Technical Note

Project	Winchester School of Art	Project No	14398
Subject	HCC Highways Post-Submission Comments	Date	21 August 2026
File Ref	14398-CRH-XX-XX-RP-H-6005_P3_HCCHighwaysTN.docx	Pages	33

1.1 Introduction

Drawing:
**MAJOR WORKS
SITEWIDE HARDWORKS PLAN**

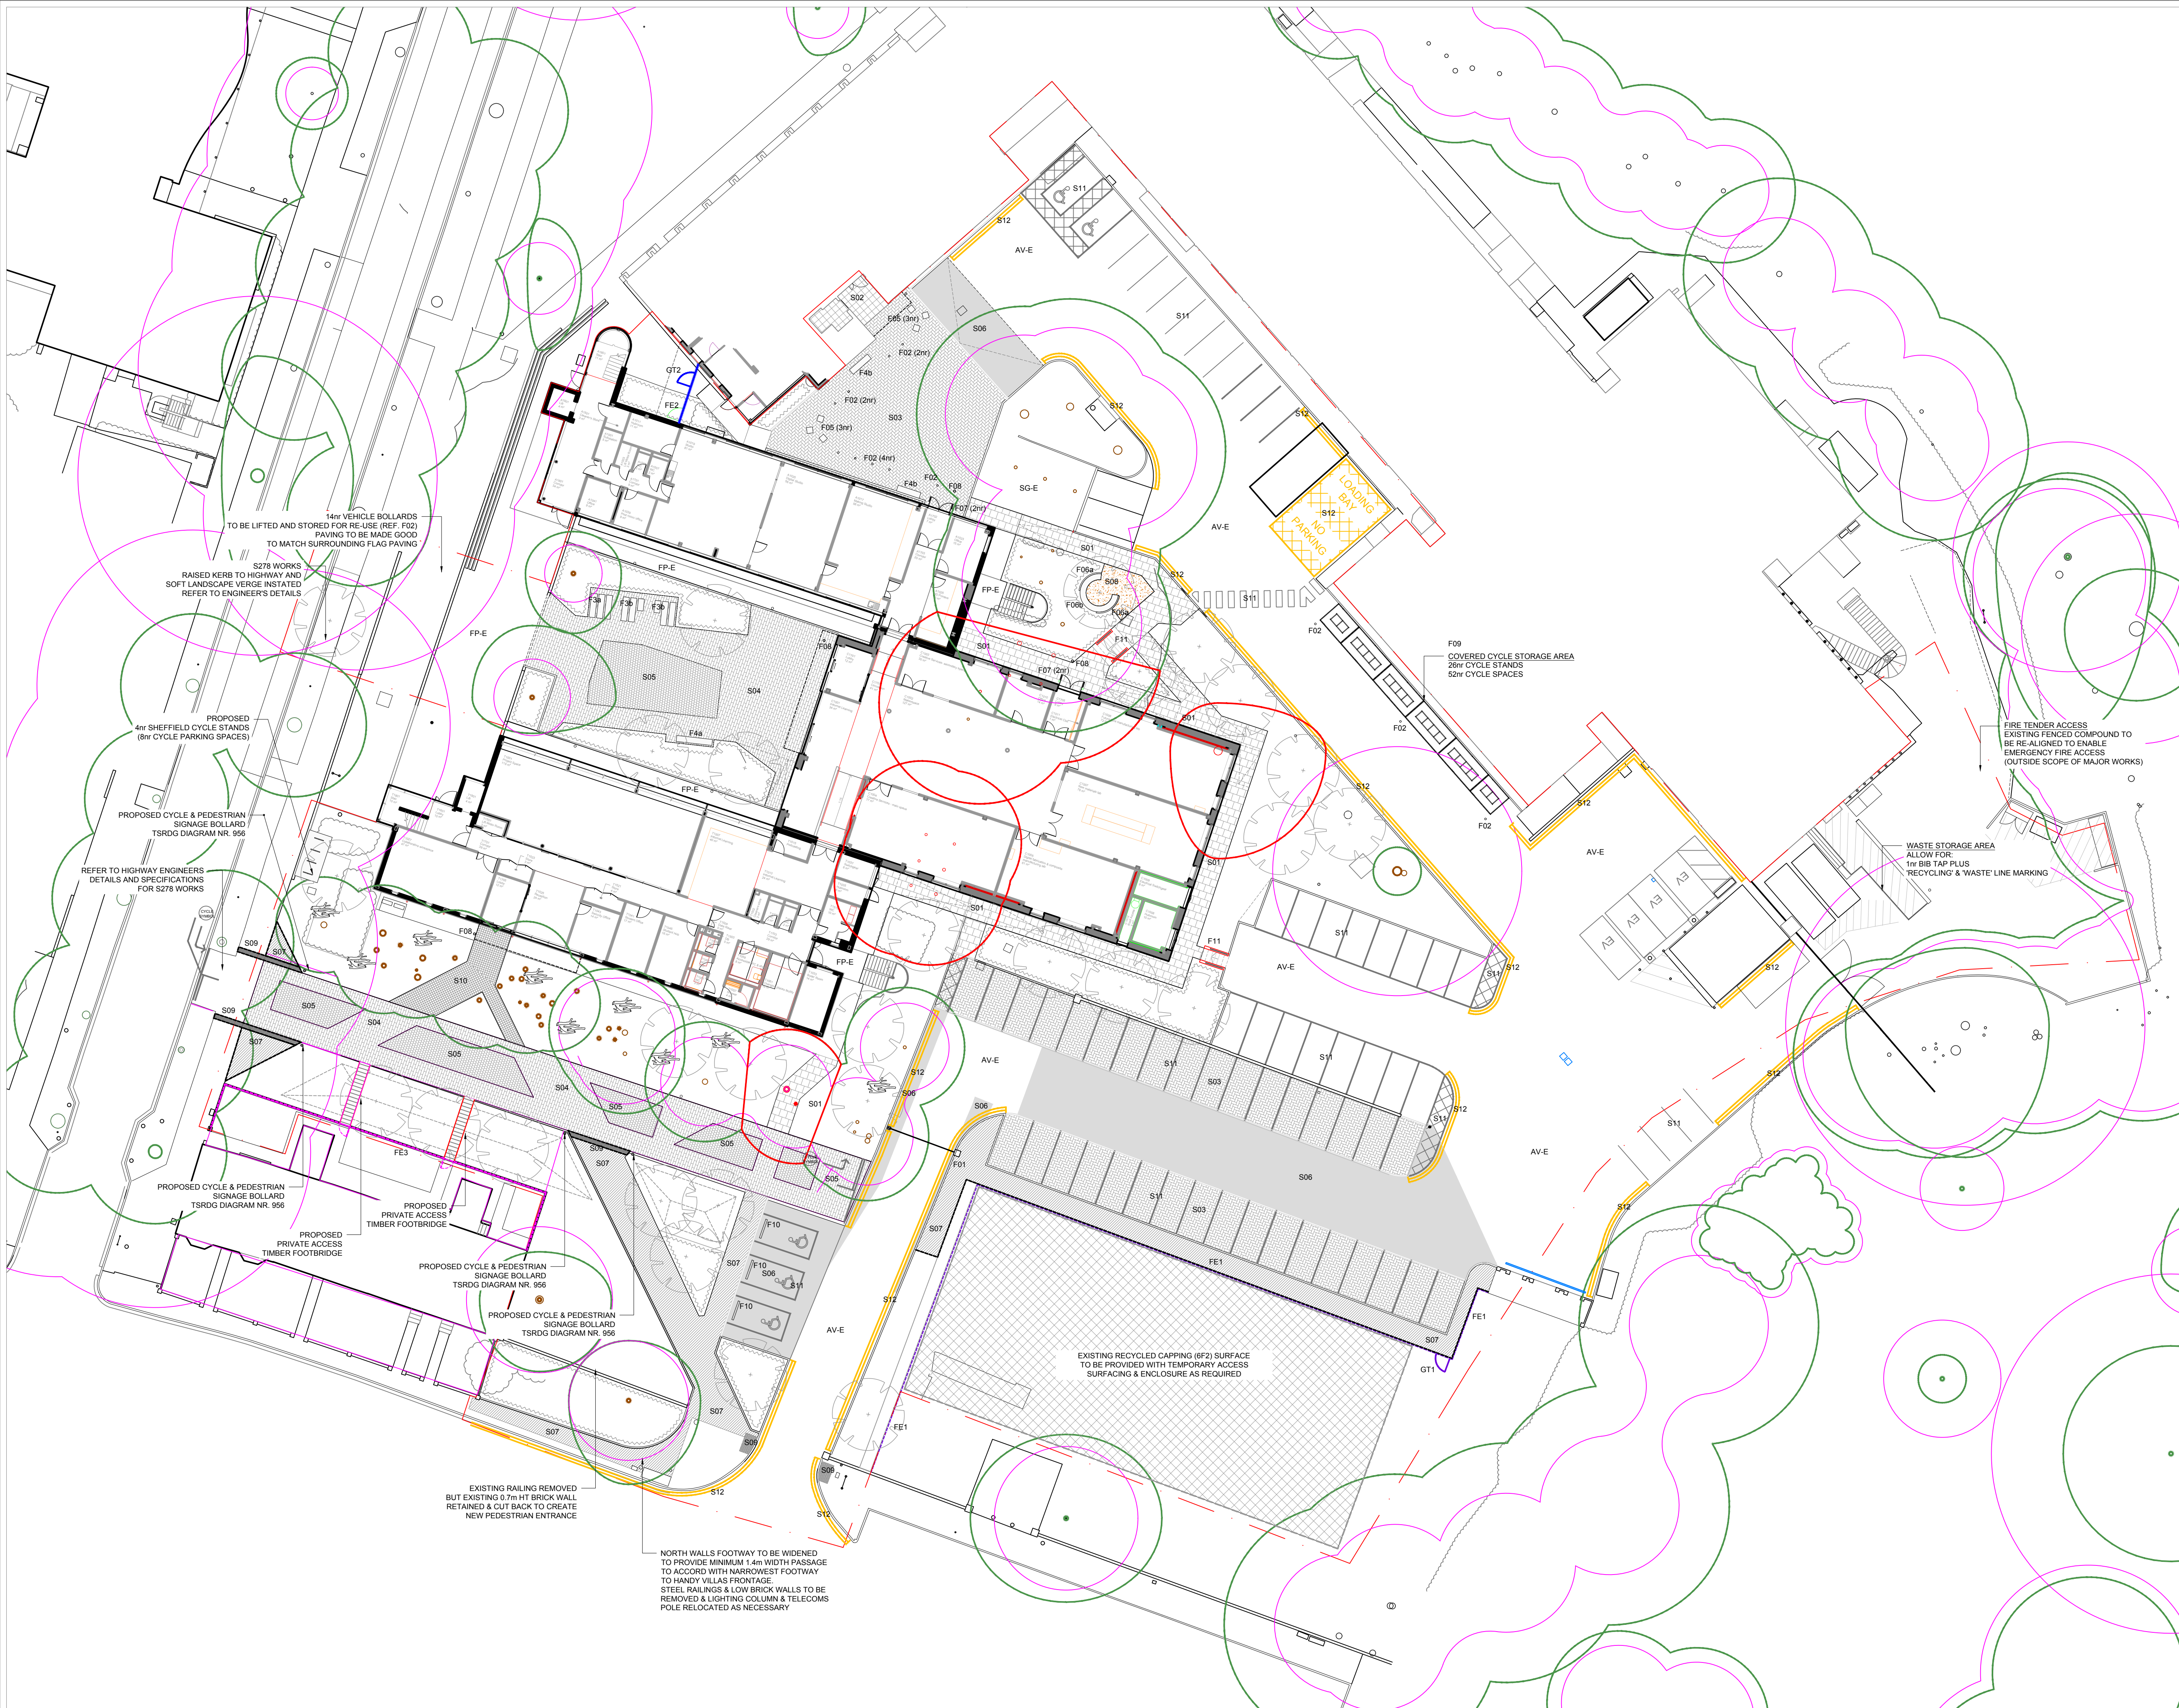
1.2.3 HCC have stated that the proposed short-stay cycle parking spaces are “not clearly identified on the submitted plans and further detail is required.”

1.2.4 With reference to Drawing No. 0781-PLI-XX-ZZ-DR-L-0100, by Plincke, within **Appendix 4**, a total of 4 No. Sheffield Stands are situated to the north of the proposed shared foot/cycleway route off Park Avenue, providing a total of 8 No. short-stay cycle parking including provision for 2 No. enlarged/cargo-style cycle parking spaces, contained within the same area.
